**Our Case Number: ABP-317767-23**

**Re: Proposed construction of 39 residential units, widening of Pausdeen Bridge and all associated site works.  
Newtown/Ardclough Road, Newtown, Celbridge, Co. Kildare.**

## Planning Observation Submissions to An Bord Pleanála - Updated 260923 Rev 2

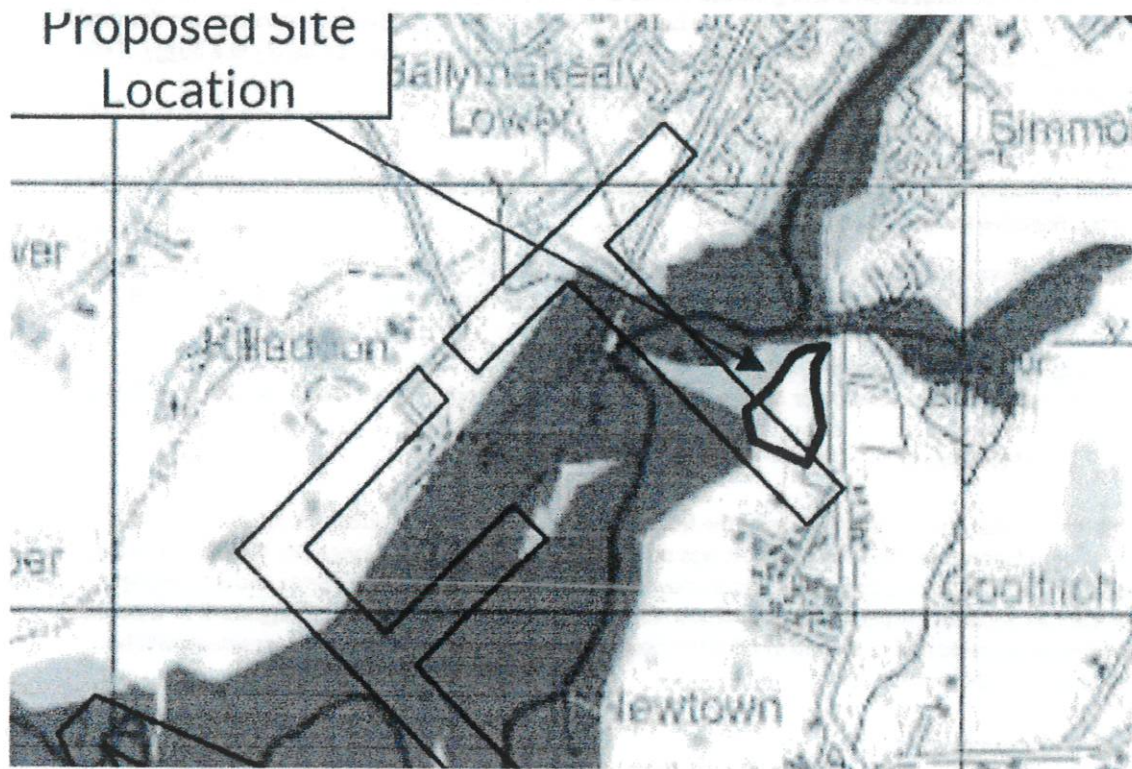
**Historical Flooding:** Local Residents believe that Tobin Consultants view that the most recent event in the area in 1954 is inaccurate and flooding occurred in 1993, 1998 and 2000

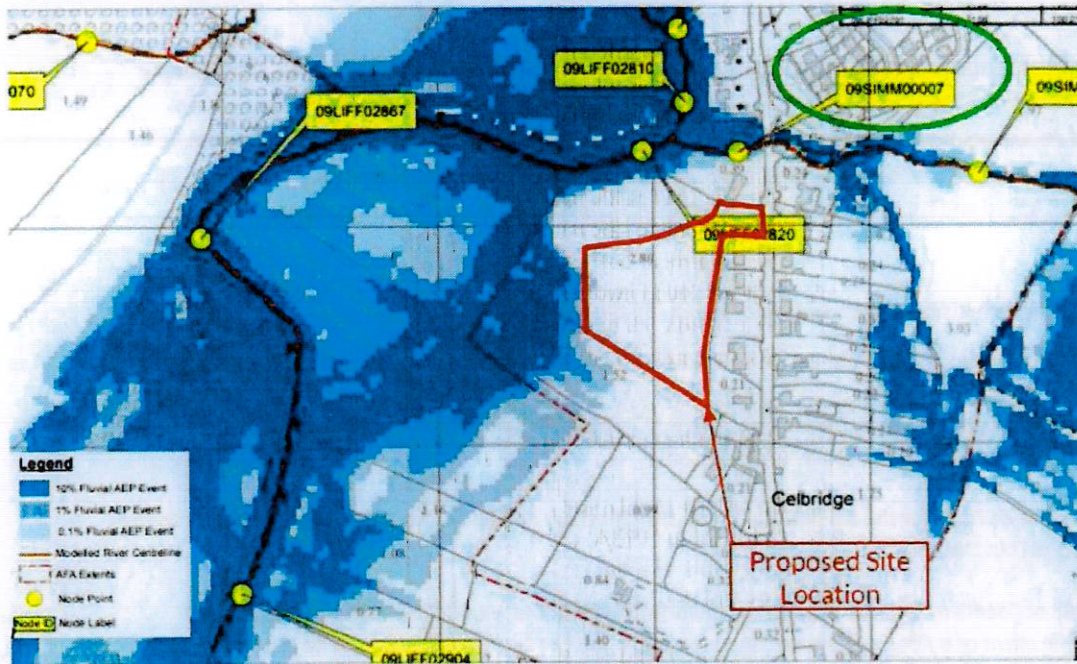
*I have circled Chelmsford in green. The properties in the proposed site will not be able to obtain home insurance with flood cover included."*

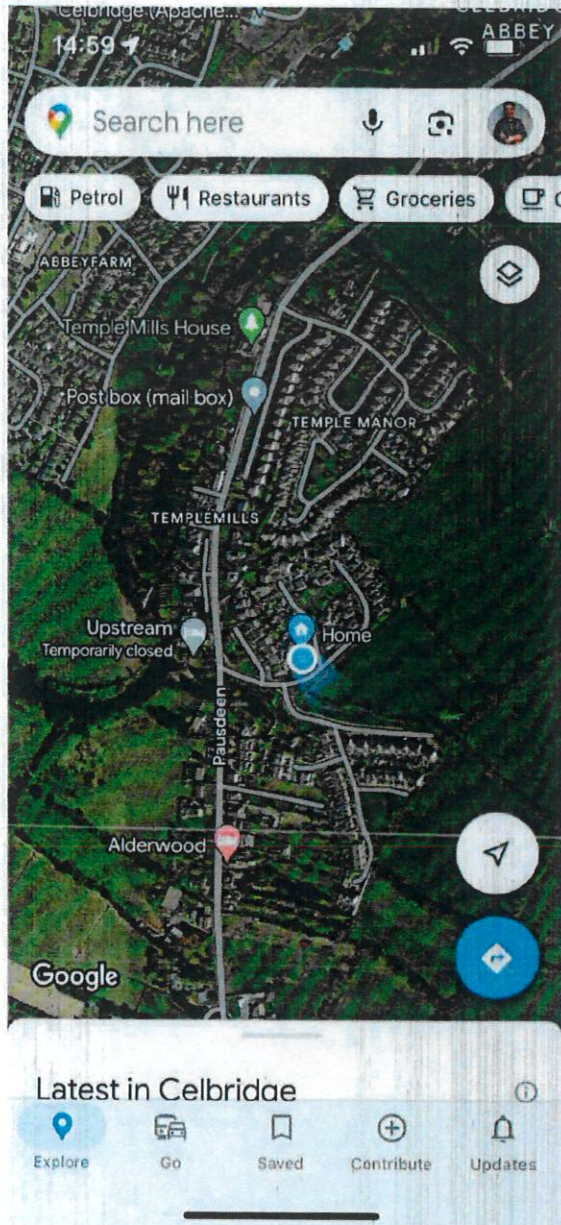
The diagram below shows that the site boundary (40m from river) would be the closest development to the flood plain on the west side of the Ardclough Road. No other development is as close to the Liffey flood zone on the southern side of the river.

New proposed pedestrian crossing

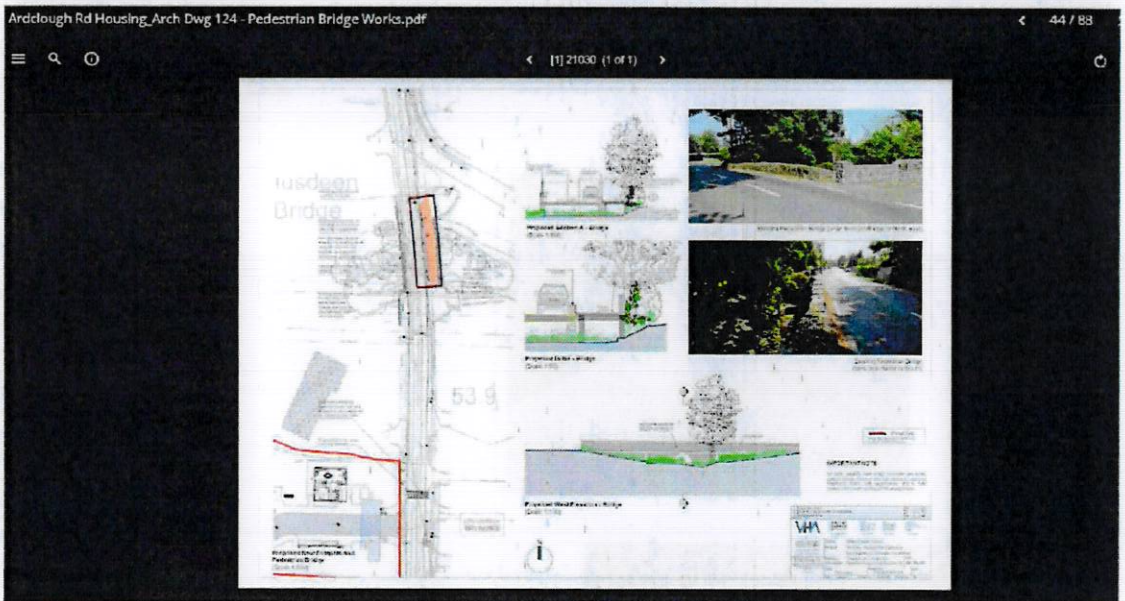
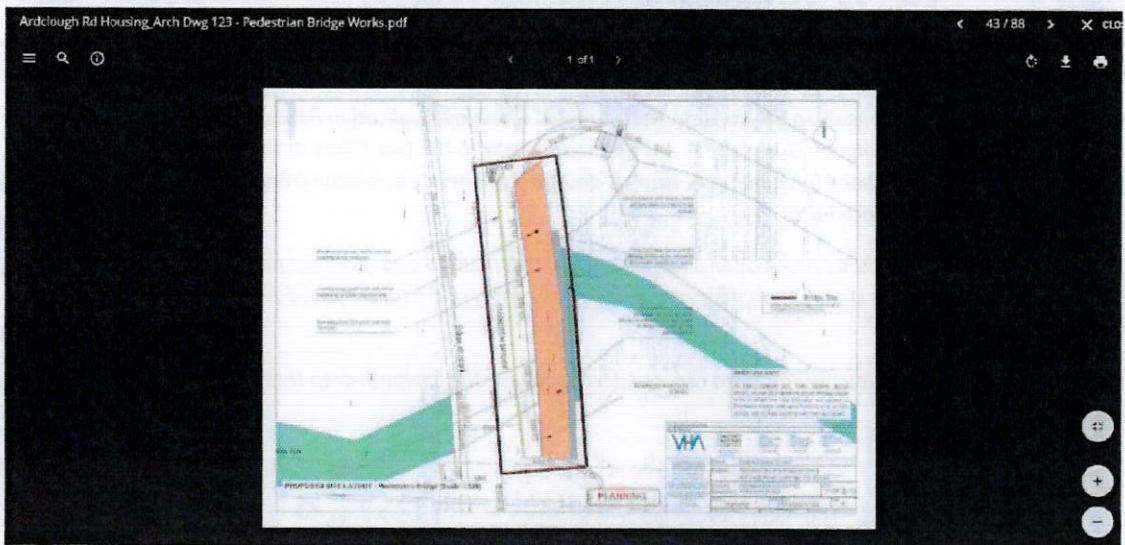
The information in the Bruton Consulting Engineering Report or KCC Planning Application Report does not consider the ownership of the Common Green Areas at Entrance along with the two Pillars at the entrance to Chelmsford. The lands are not owned by the County Council, and they will need permission from the owner to carry out any works on this proposed site.

Also, clarification (in writing) as to how KCC were granted permission for the footpath area that was constructed in 2022?

**Resolution:** The Chelmsford Residents Association should be given documented evidence that permission from the owner that any works on the planning application for bridge widening and new proposed zebra crossing has been given.
